Memorandum to the City of Markham Committee of Adjustment
September 15, 2025

File: A/092/25
Applicant: Cornell Rouge Development Corporation
Agent: State Building Group (Andy Margaritis)
Hearing Date: Wednesday, September 24, 2025

The applicant is requesting relief from the following requirements of the Residential Two (R2*190*192) zone under By-law 177-96, as amended, to permit:

PLAN OF SURVEY OF
BLOCK 21
REGISTERED PLAN 65M-4545
CITY OF MARKHAM
REGIONAL MUNICIPALITY OF YORK
SCALE 1 : 150
SCHAEFFER DZALDOV PURCELL LTD.

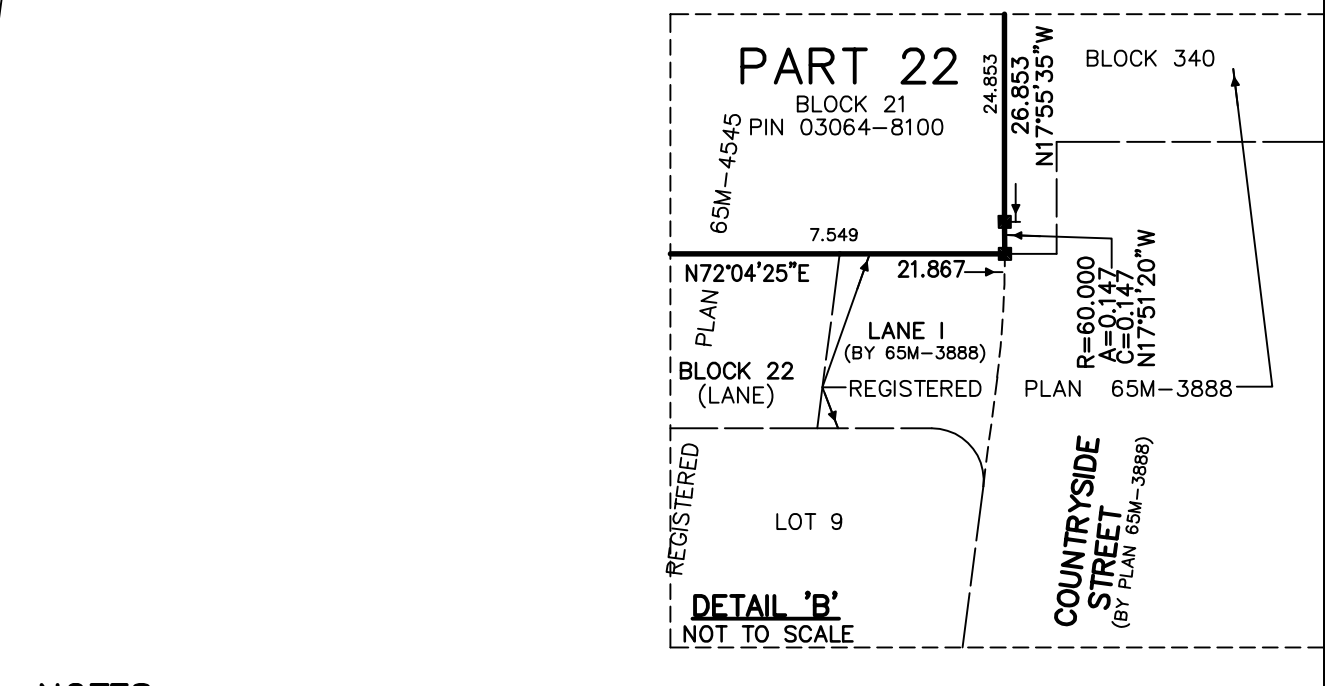
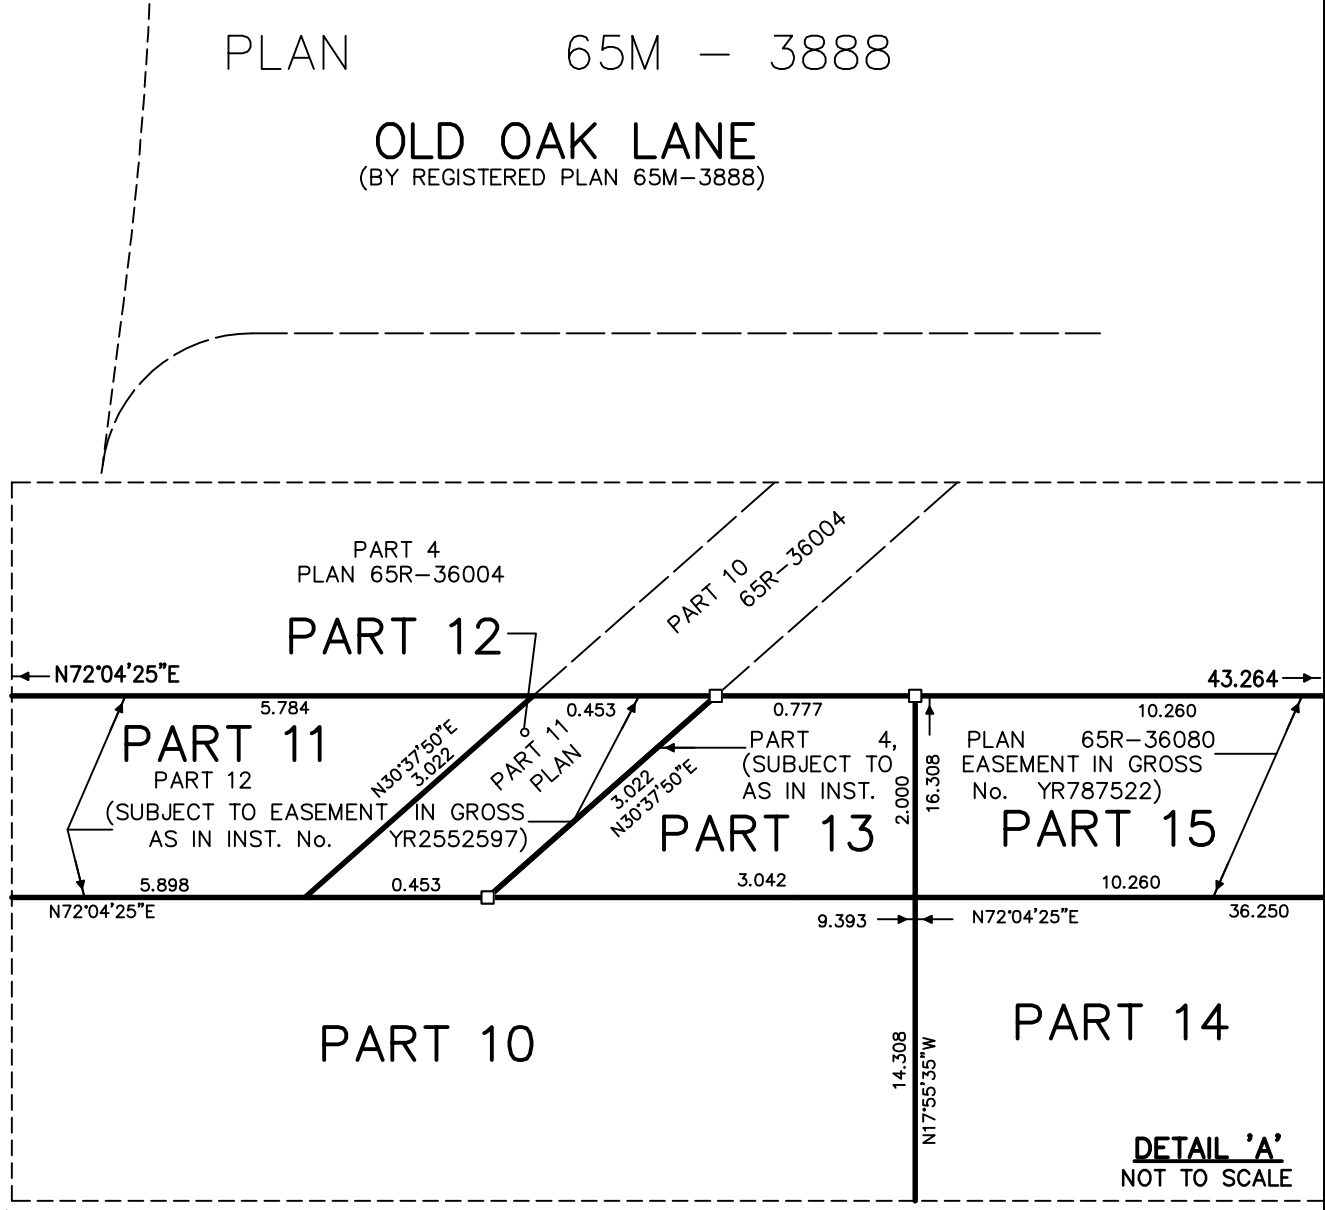
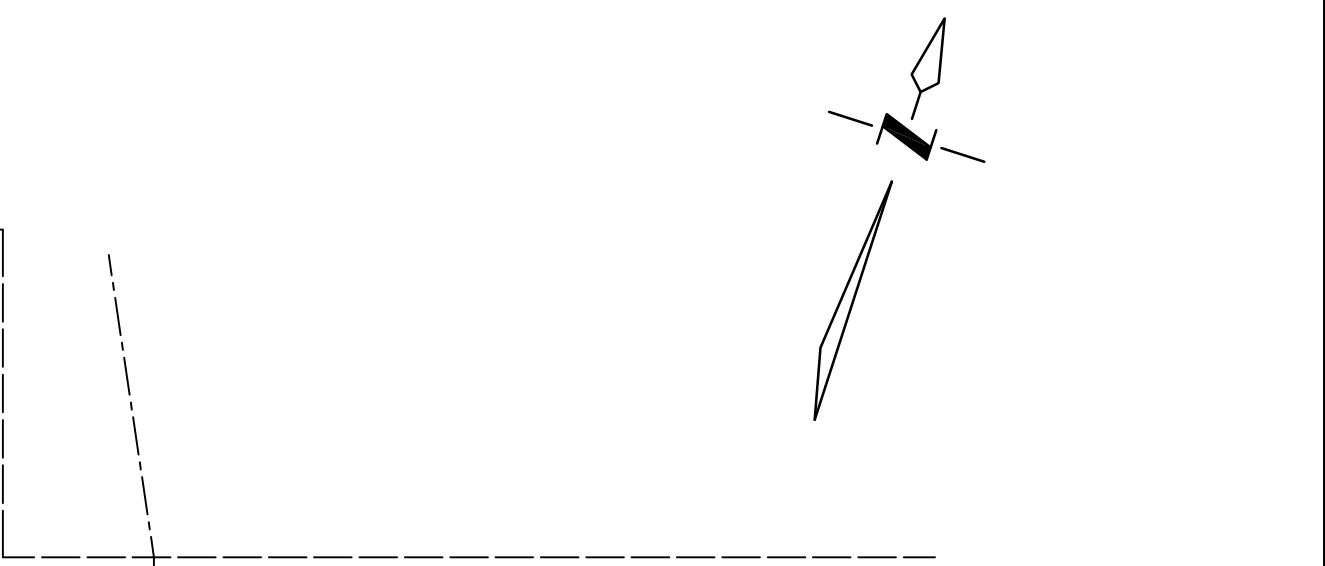
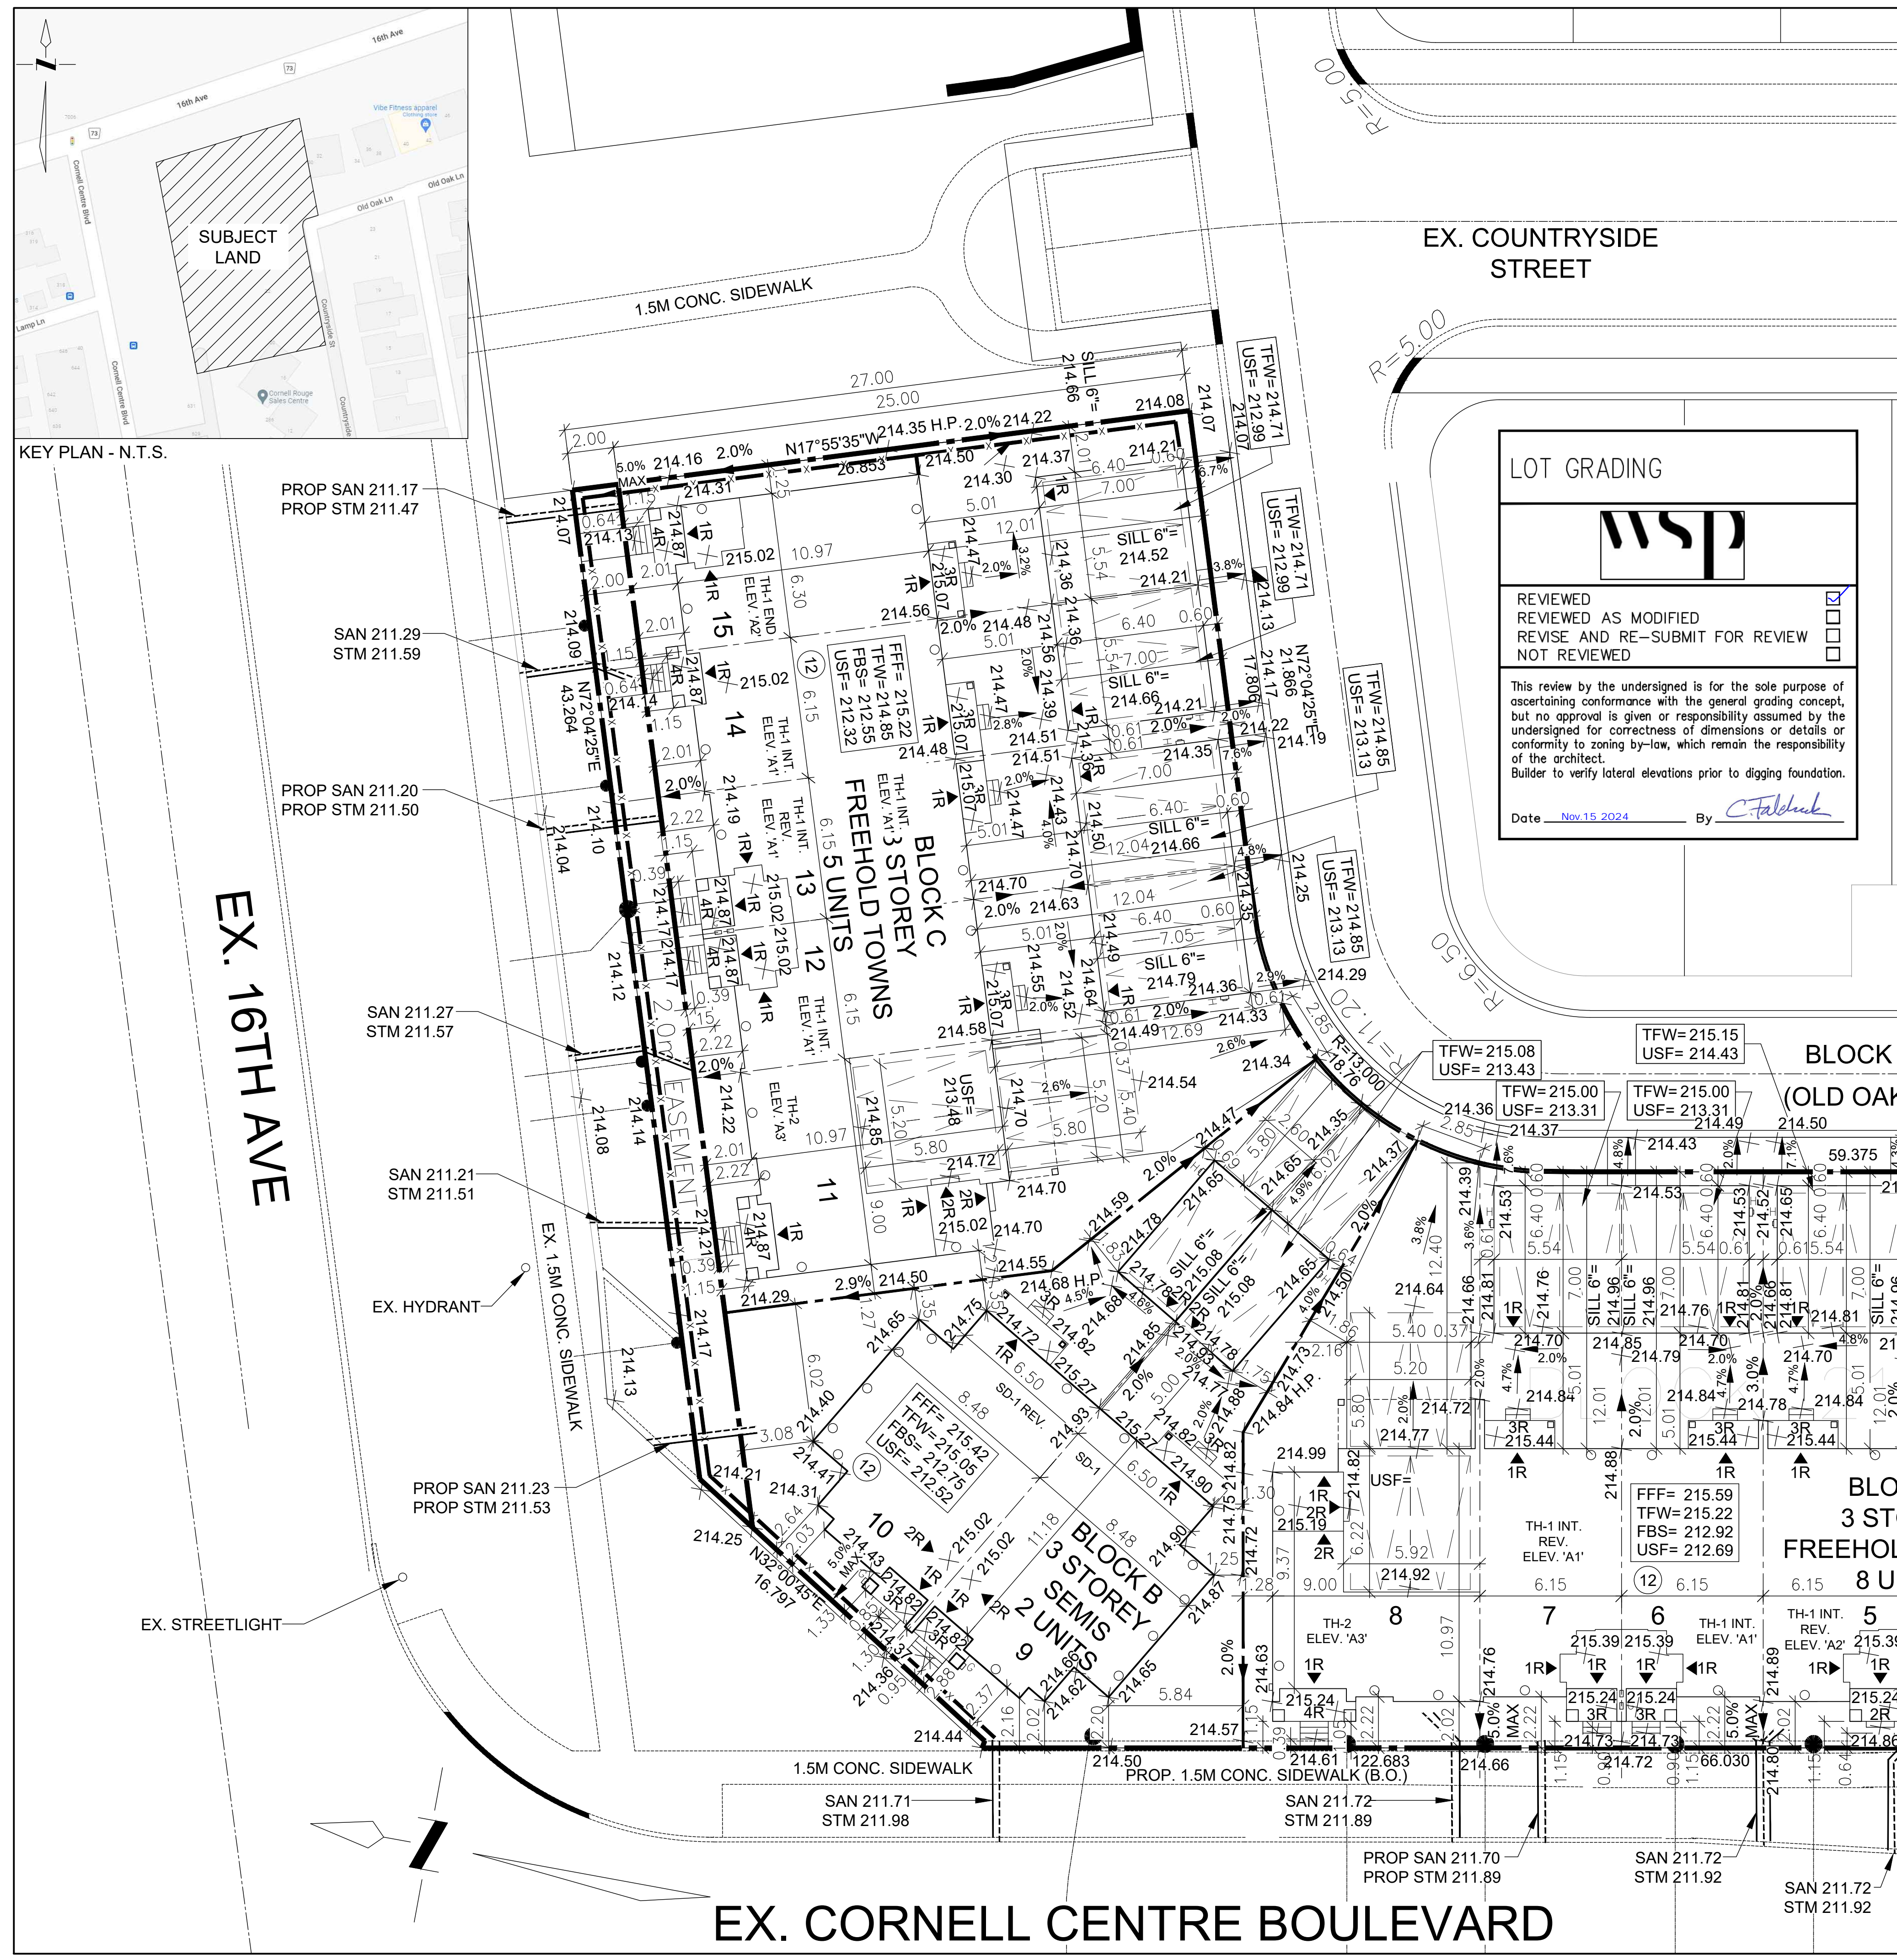
Reduction in Front Yard Setback - Part of Block 21, Parts 1 to 8 (Townhouse Lots)

The applicant is requesting relief to permit a minimum front yard setback of 6.56 ft (2 m), whereas the By-law requires a minimum front yard setback of 9.84 ft (3 m). This represents a reduction of approximately 3.28 ft (1 m).

A previous Minor Variance application (A/002/23) was approved in 2023 for other lots within the overall subdivision to allow a reduction to the front yard setback. Staff opine that the proposed front yard setback is consistent with the front yard setback pattern in the surrounding neighbourhood and consider the requested variance to be minor in nature.

DRAWN BY: JP	DATE: FEB 2023
SCALE: 1 : 250	LOT NUMBER: LOT 9

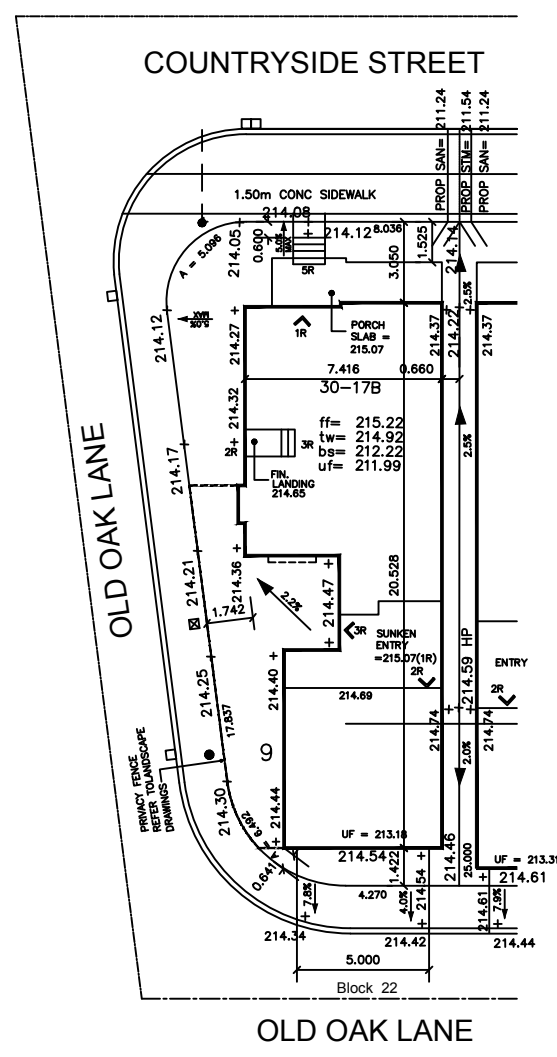
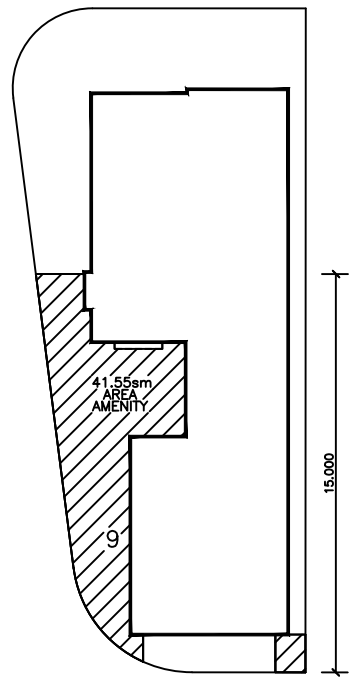
Increase in Rear Yard Setback - Lot 9 (Single Detached Lot) – 24 Countryside Street

The applicant is requesting relief to permit a maximum rear yard setback of 4.69 ft (1.43 m), whereas the By-law requires a maximum rear yard setback of 3.93 ft (1.2 m). This is an increase of approximately 0.76 ft (0.23 m)

The Owner has indicated the increased rear yard setback is required to accommodate parking in the detached garage. Staff opine the increase in the rear yard setback is minor in nature and have no concerns.

Reduced Exterior Side Yard Setback - Lot 9 (Single Detached Lot) – 24 Countryside Street

The applicant is requesting a minimum exterior side yard setback of 5.57 ft (1.7 m), whereas the by-law requires a minimum side yard setback of 7.87 ft (2.4 m). This is a reduction of approximately 2.3 ft (0.7 m).

The subject lot narrows as it reaches the rear yard. The majority of the dwelling complies with the required exterior side yard setback; however, a portion of the dwelling is non-compliant as a result in the narrowing of the lot. Staff opine that the requested variance is minor and will not adversely impact the streetscape.

DRAWN BY:	DATE:
JP	FEB 2023
SCALE:	LOT NUMBER:
1 : 250	LOT 11

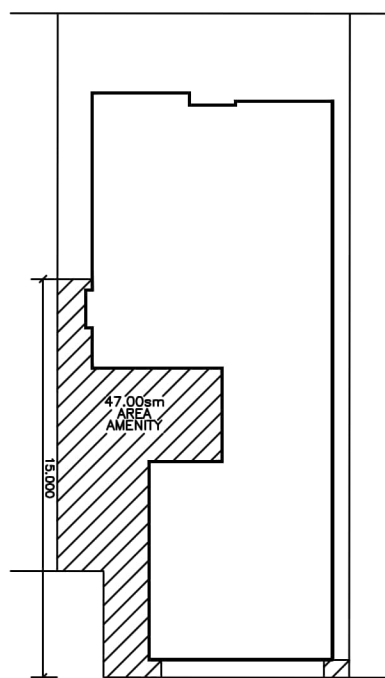
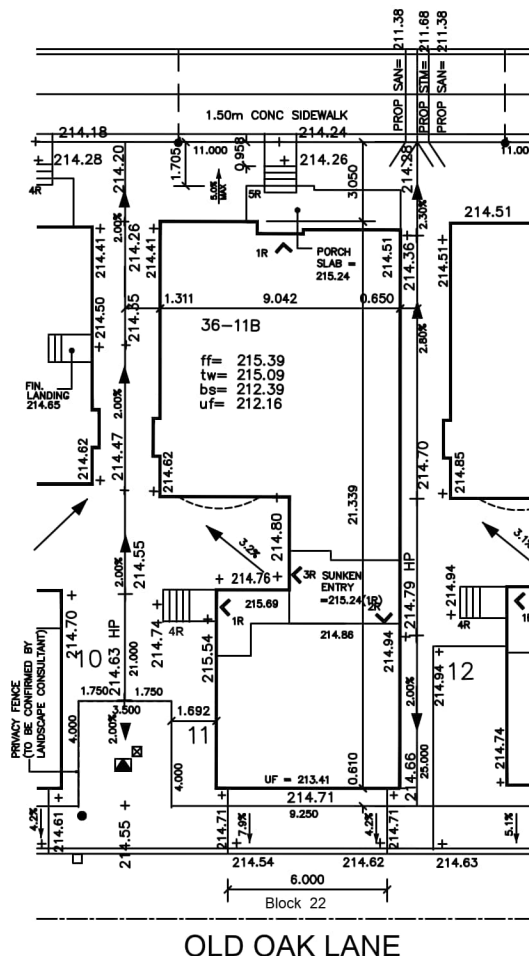
Reduced Parking Spaces - Lots 2, 6, 11 & 13 (Single Detached Lots) – 619 & 627 Cornell Centre Boulevard and 16 & 20 Countryside Street

Parking Standards By-law 28-97 requires two parking spaces to be provided for the main dwelling unit, plus one parking space for each additional dwelling unit.

The Owner is requesting a reduction in parking in the event that the future Owner's construct an additional dwelling unit. Given the parking reduction is only required if an additional dwelling unit is provided, Staff recommend that a condition is included indicating that the parking reduction only applies if an additional dwelling unit is constructed (refer to Appendix A – Conditions of Approval). Staff have no concerns with the requested variance.
